CITY OF MADISON

PLAN OF PROPOSED IMPROVEMENT

531 W WASHINGTON AVENUE

Revised 2/14/2024
Sheet P1
Sheets U1-U4
Sheet X1

14500	MADISON, WI	9274	CONTRACT NO.:
PLAN & PROFILE - W WASHINGTON AVENUE 531 W WASHINGTON AVE M:\DESIGN\Projects\14500\CAD\Streets\14500EN-PnP.dwg			
14500	P-1

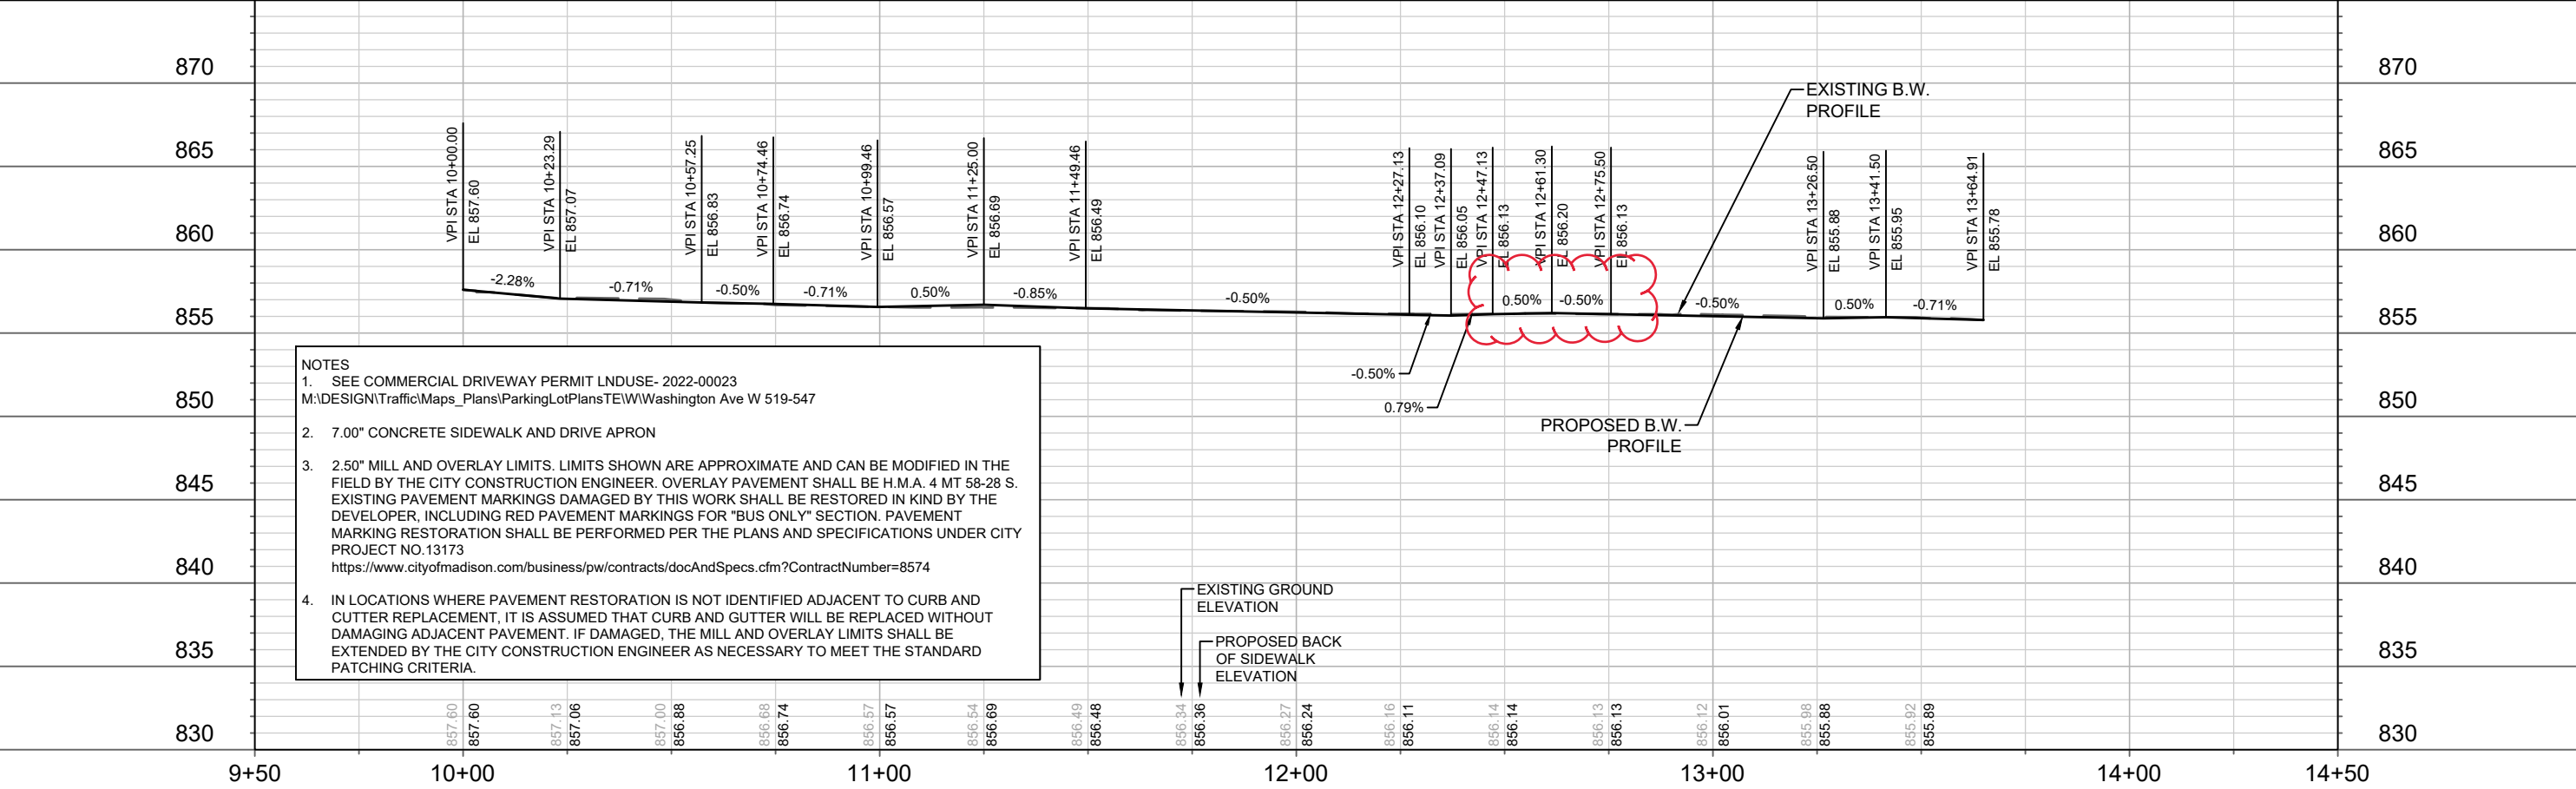
REVISION #1: 02/14/2024
 1. REVISED GRADES FROM STATION 12+47.13 TO 12+75.50
 2. EXTENDED SIDEWALK REPLACEMENT LIMITS

UTILITIES PLAN & PROFILE - WEST WASHINGTON AVENUE (SEWER PLUGS)
 531 WEST WASHINGTON AVENUE
 M:\DESIGN\Projects\14500\CAD\Sewers\14500SWR-PipeNetwork_REV1.dwg

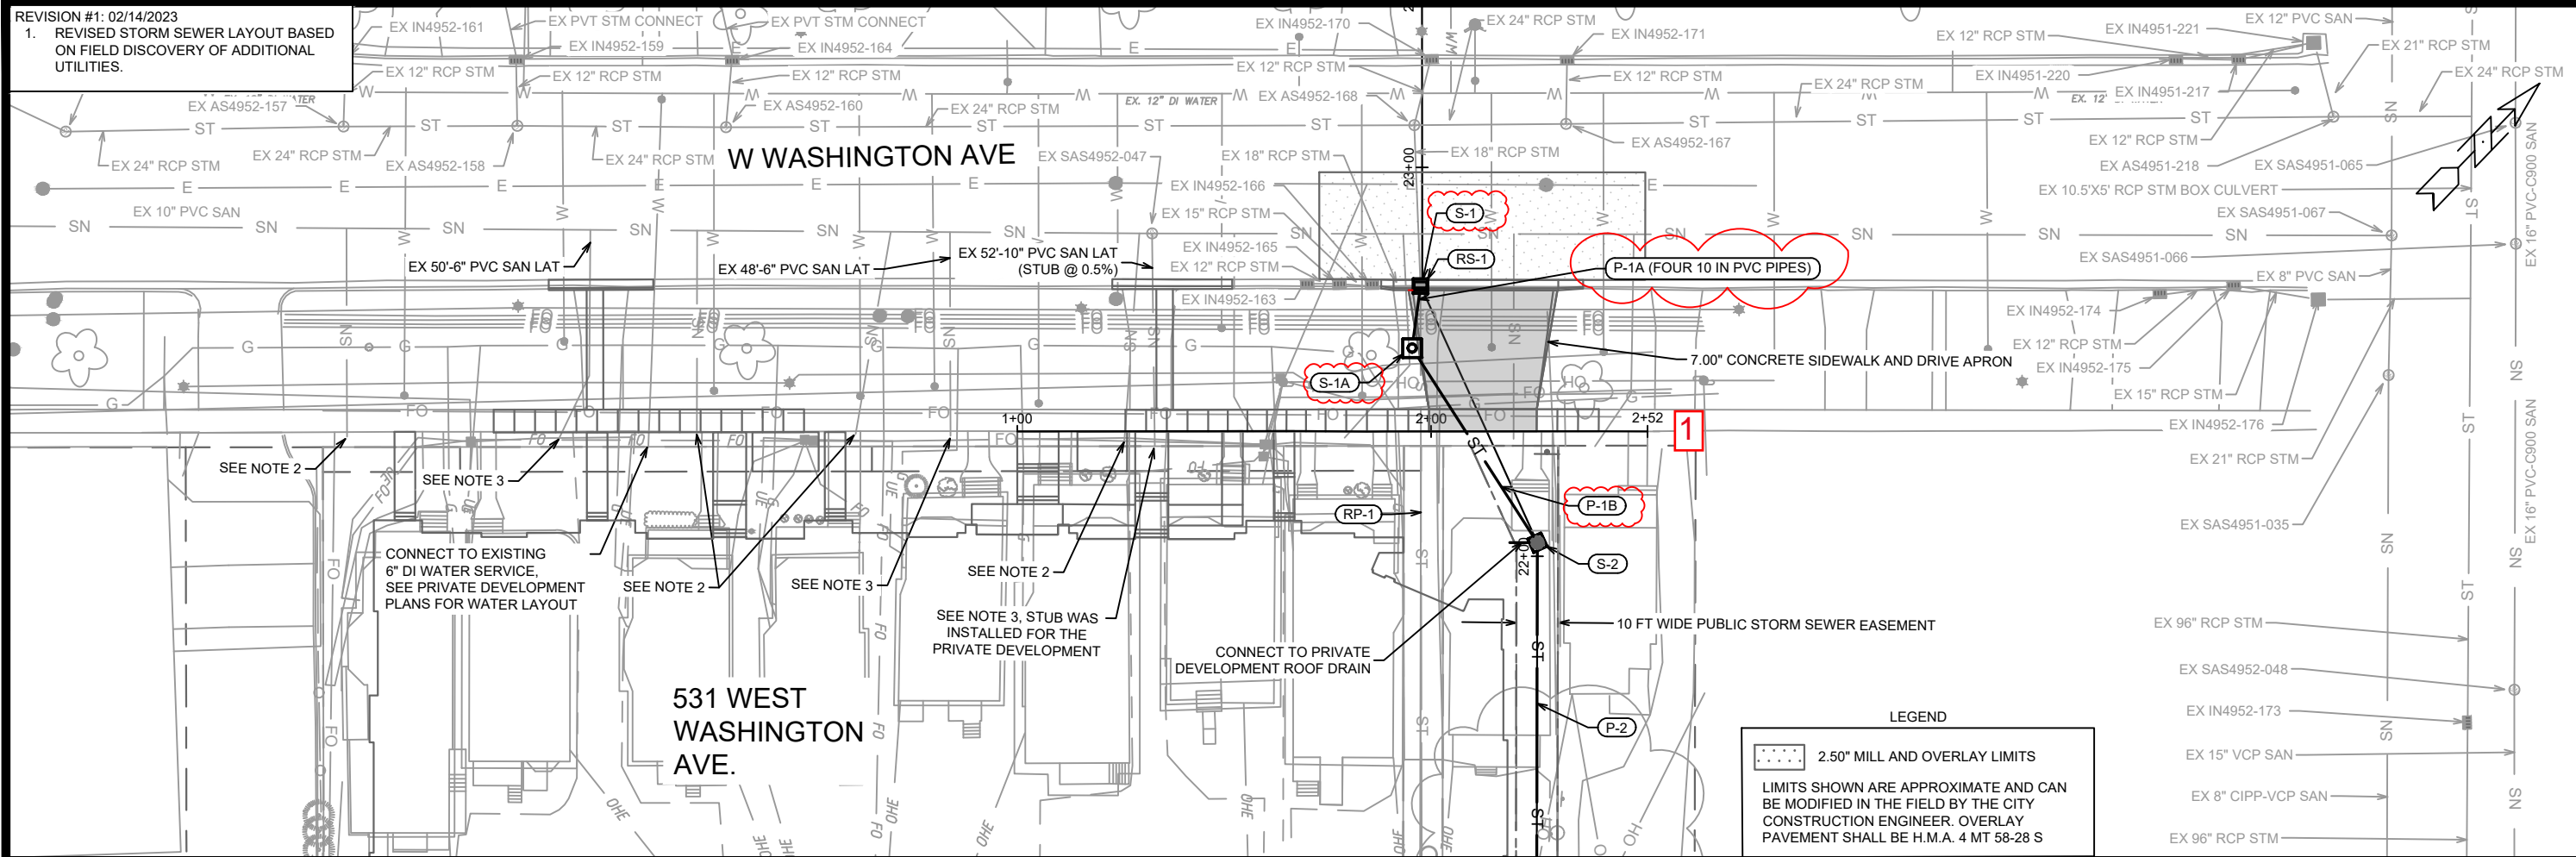
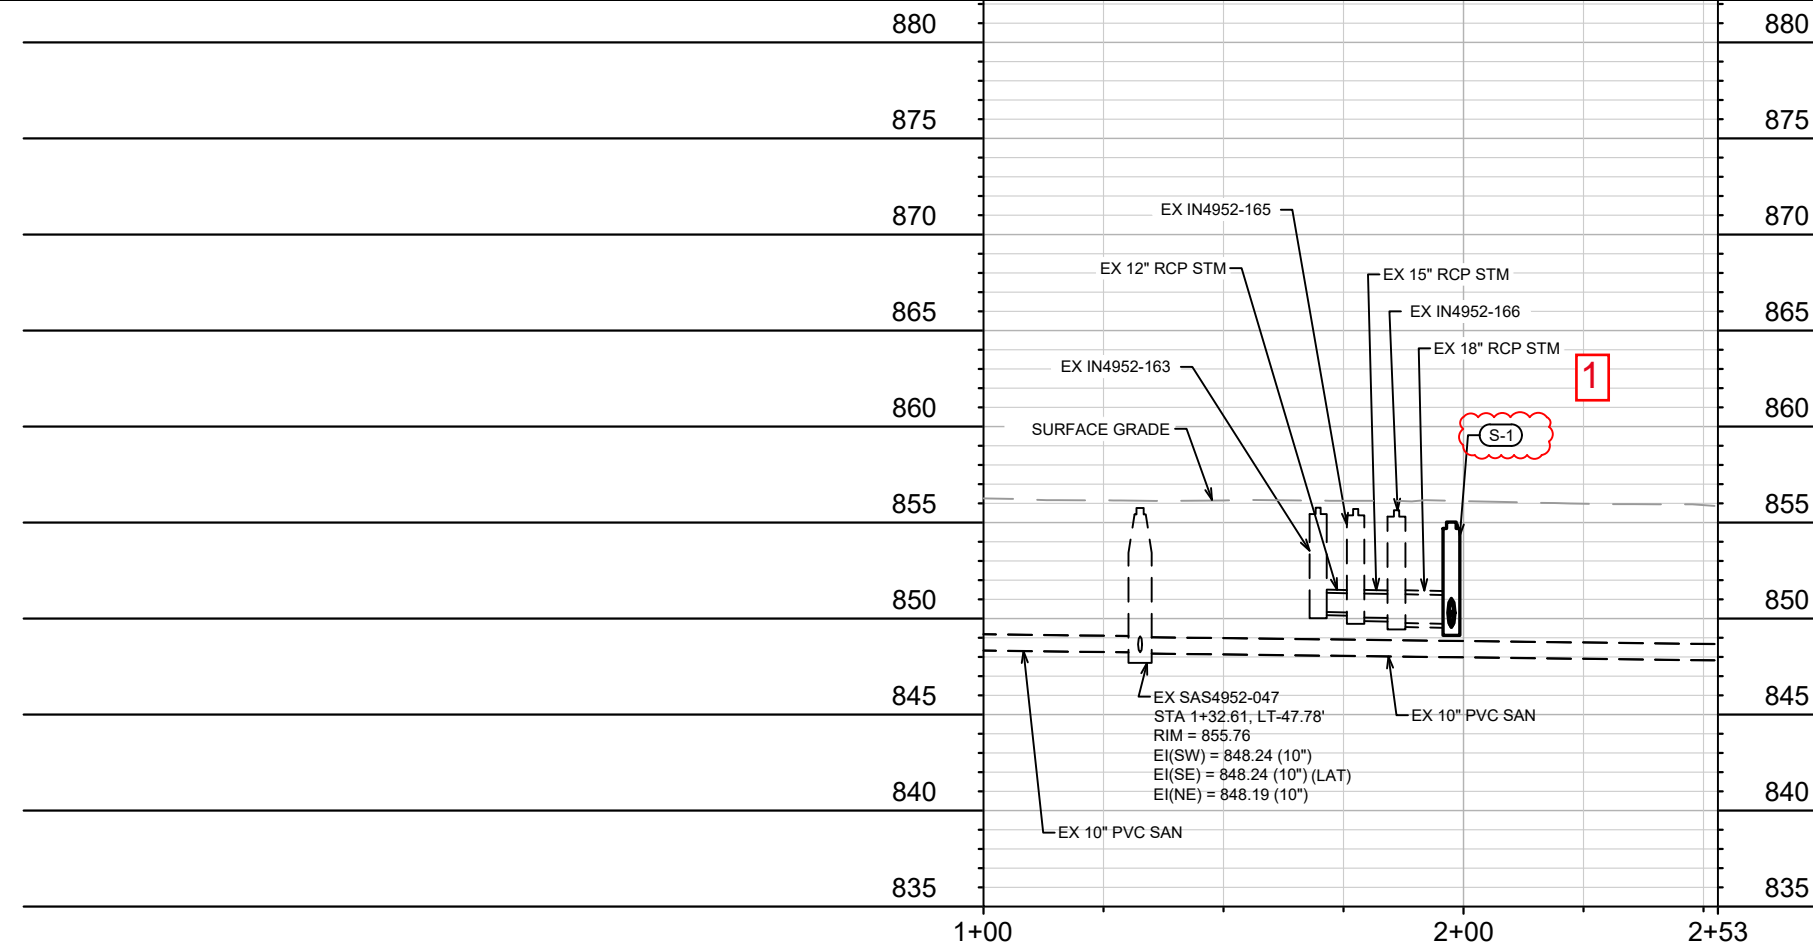
REVISION #1: 02/14/2023
 1. REVISED STORM SEWER LAYOUT BASED ON FIELD DISCOVERY OF ADDITIONAL UTILITIES.

UTILITIES PLAN & PROFILE - WEST WASHINGTON AVENUE (ULOS)
 531 WEST WASHINGTON AVENUE
 M:\DESIGN\Projects\14500\CAD\Sewers\14500SWR-PipeNetwork_REV1.dwg

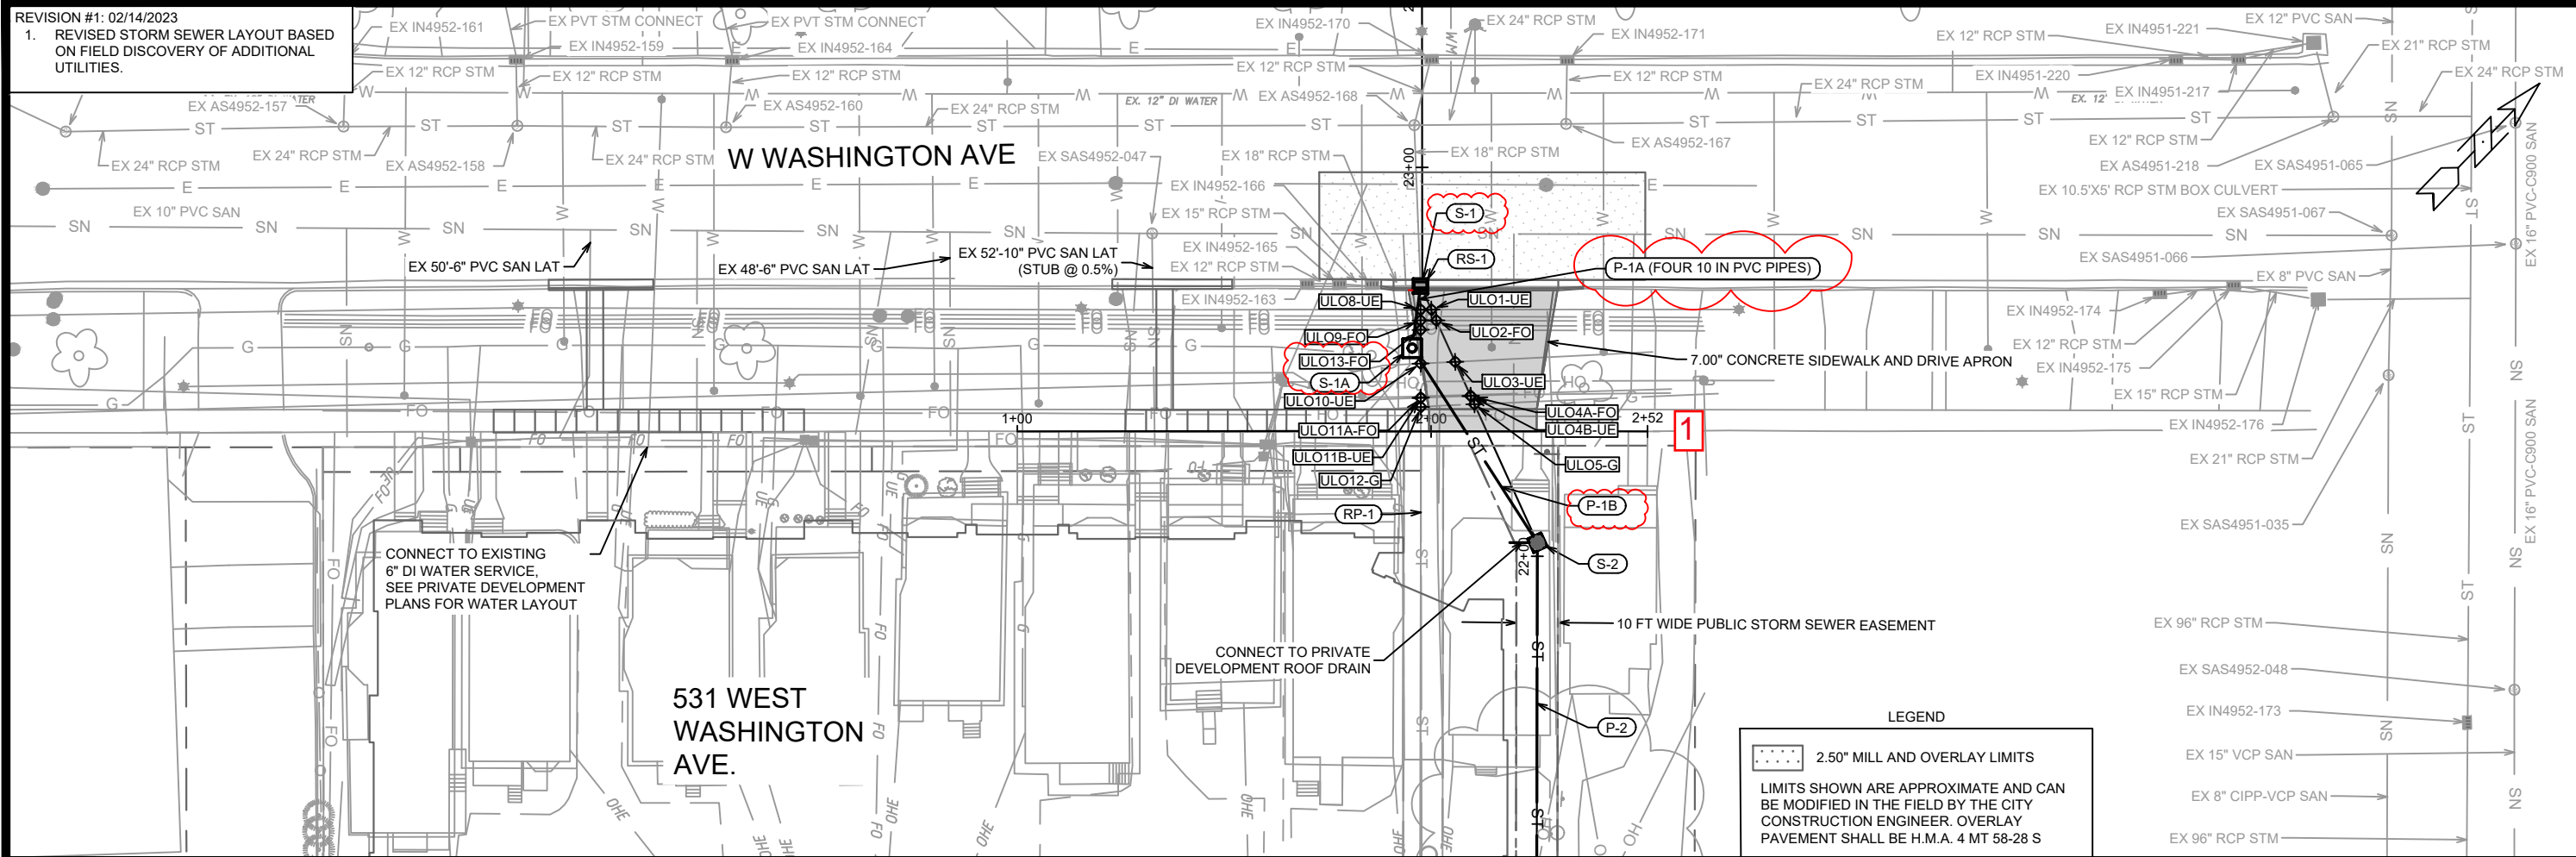
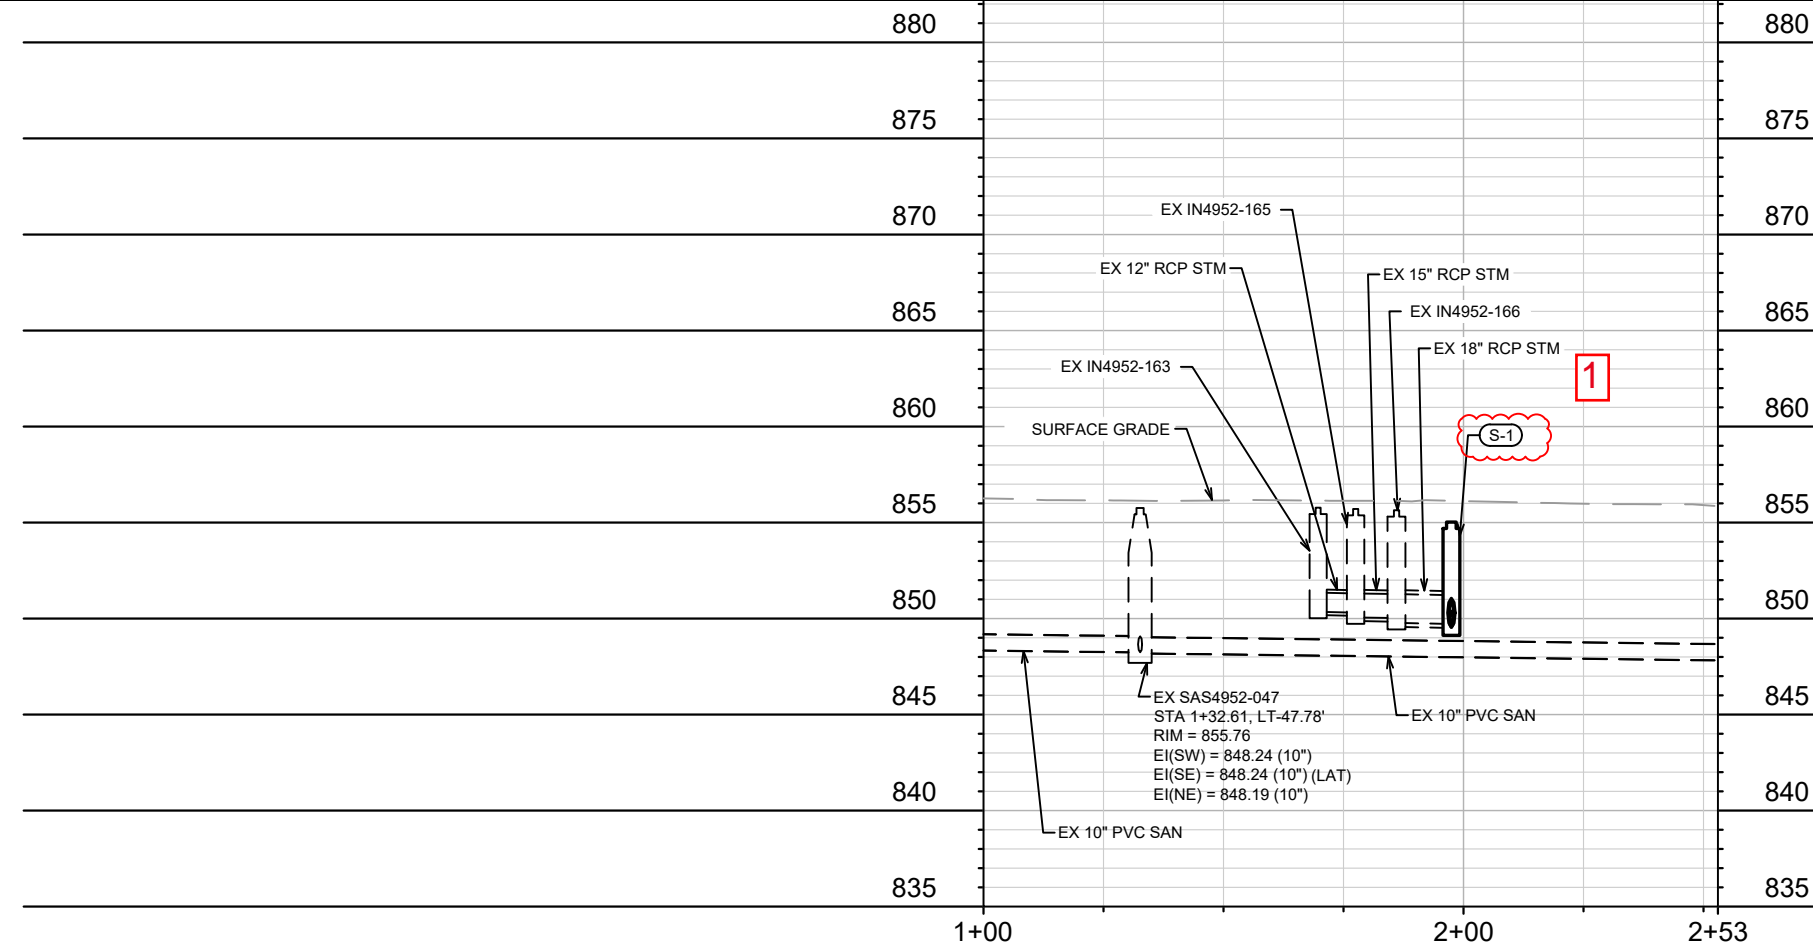
REVISION #1: 02/14/2023
 1. REVISED STORM SEWER LAYOUT BASED ON FIELD DISCOVERY OF ADDITIONAL UTILITIES.

MARK	REVISION	DATE	BY
1	STORM SEWER REVISION - FIELD ULOS	2/14/24	EAC
